**Project Name:** \* Bridge 9 over South River on US 13

B-4635

Subject: **Request for Additional Information for T.I.P. B-4635 (Replacement of Bridge 9 over South River Overflow on US 13, Sampson County)**

6/23/16

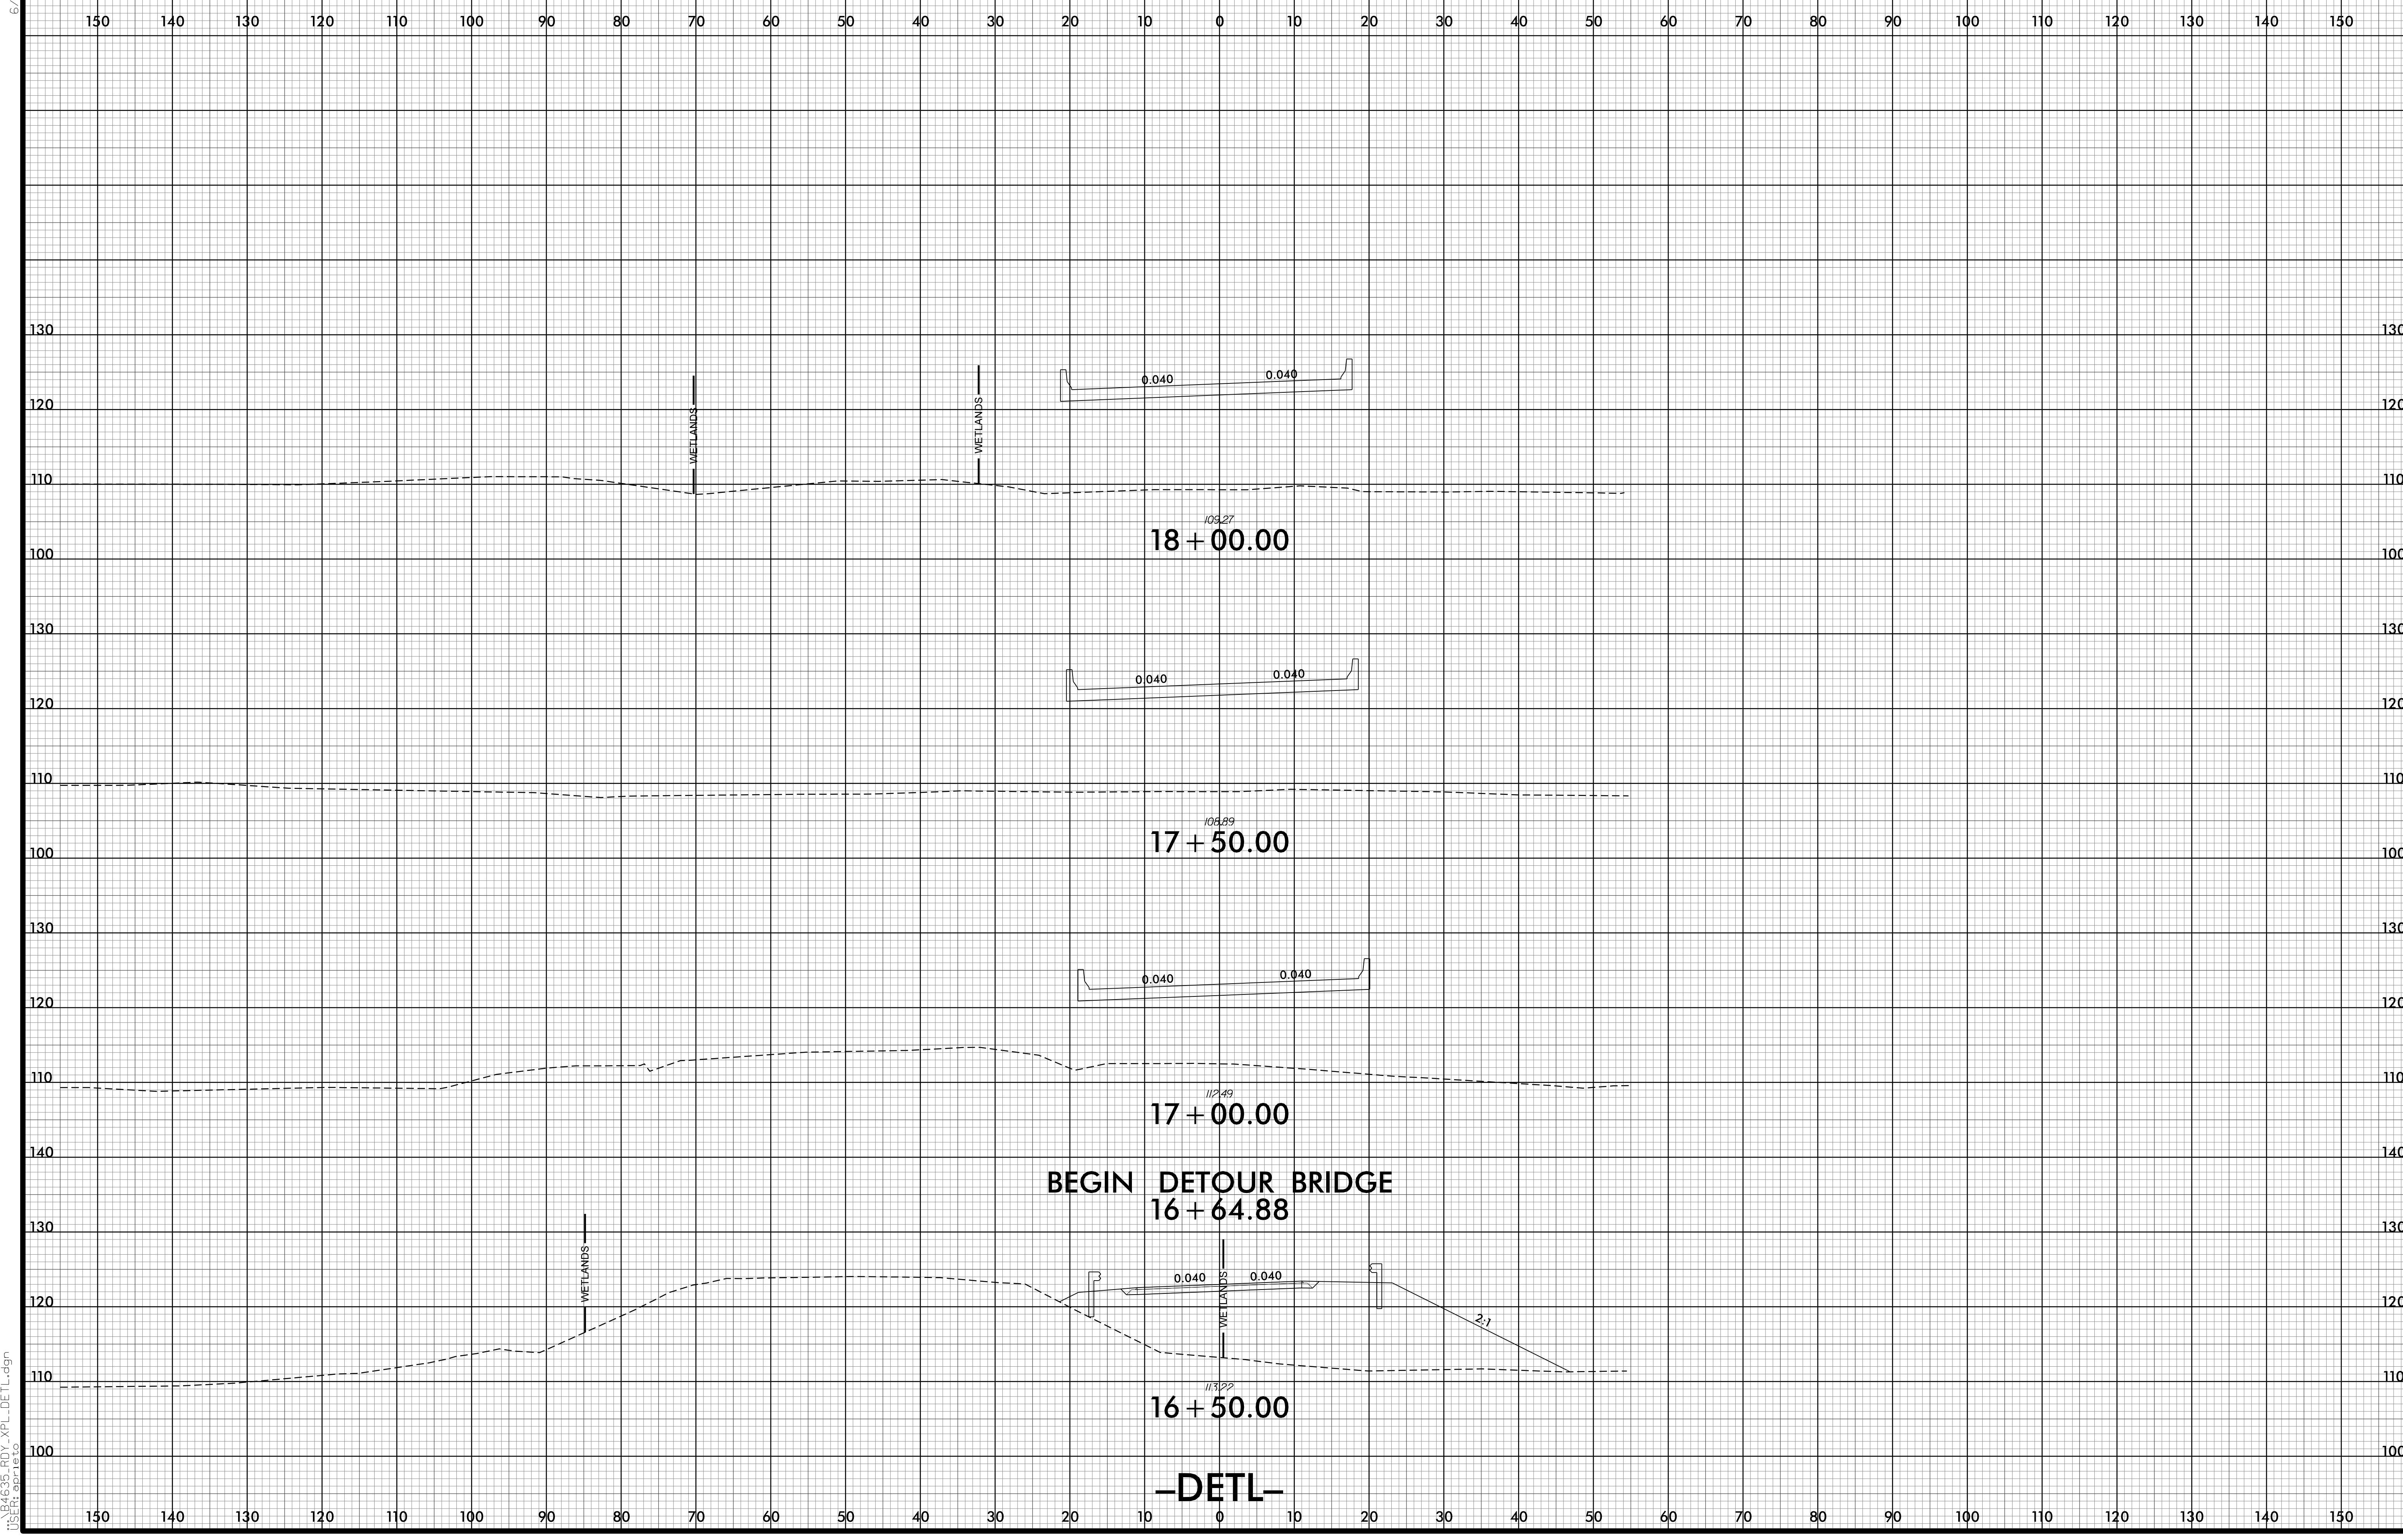
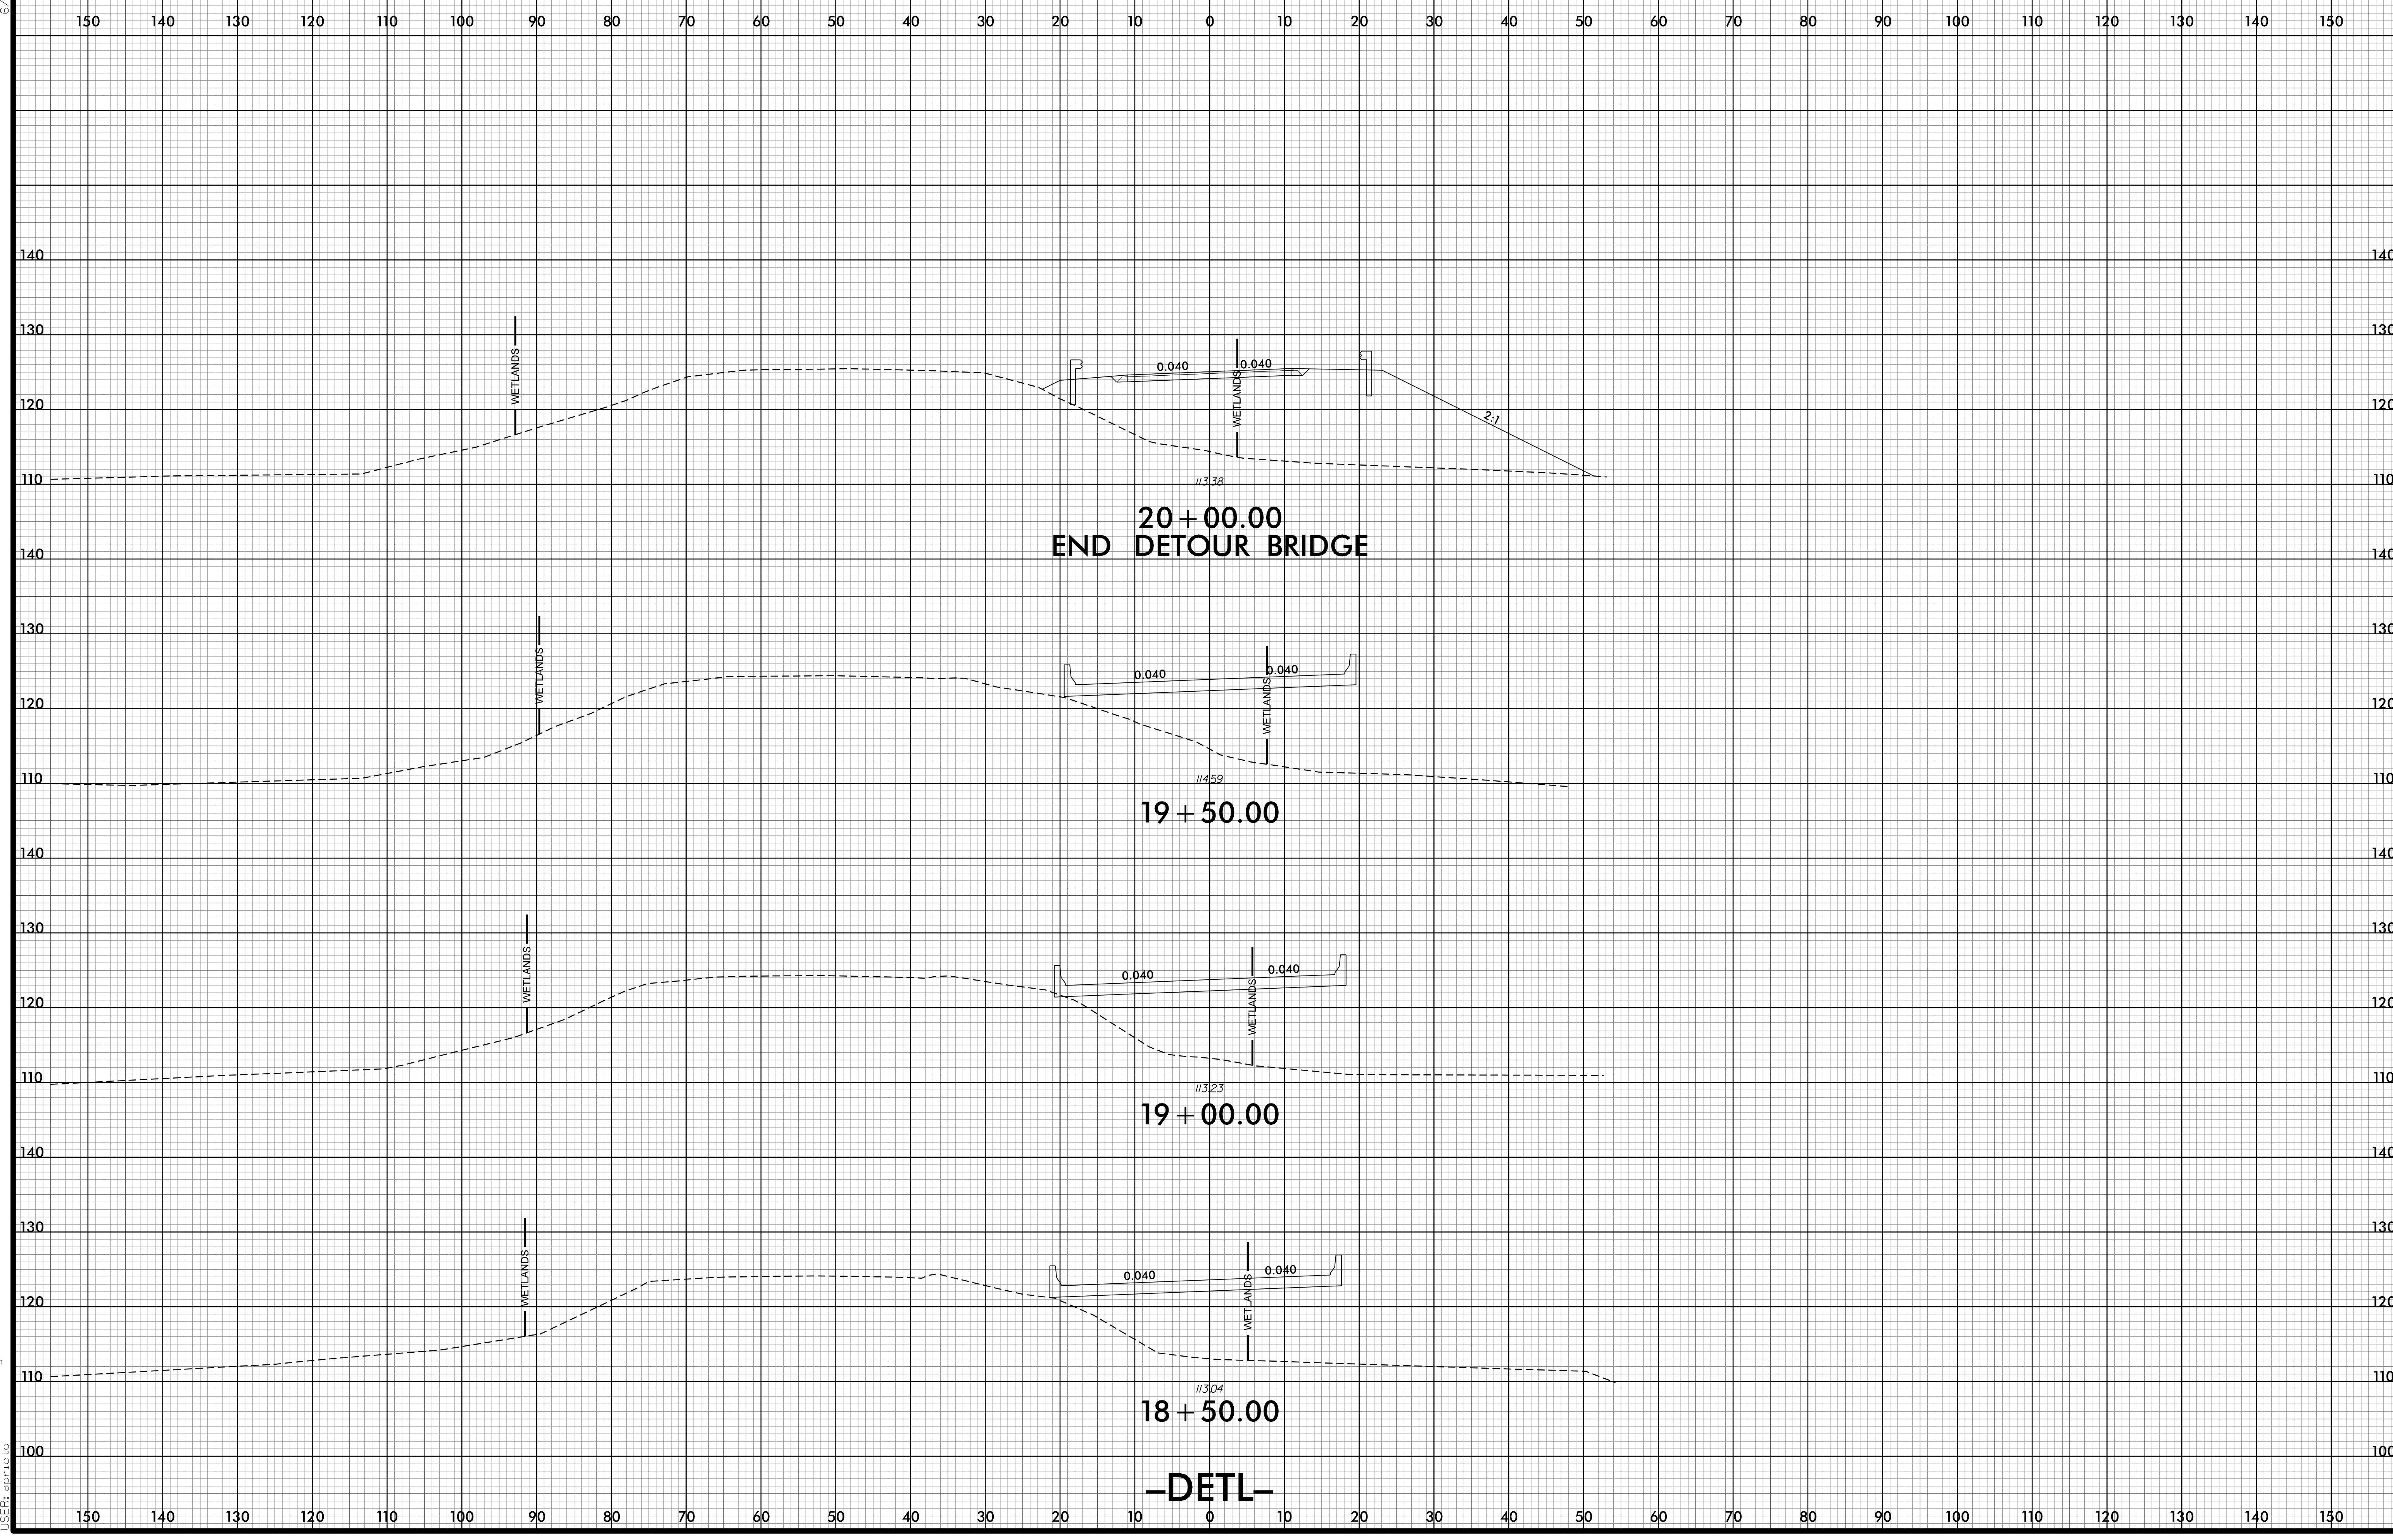
-there is no slope listed in the cross section drawings regarding the temp detour which leads to the question, could the slope be steeper than 3:1 since it would most likely be constructed with a rock base thus reducing the amount of temporary impact? **Cross sections of the detour are included in revised drawings to show 2:1 slopes along the detour.**
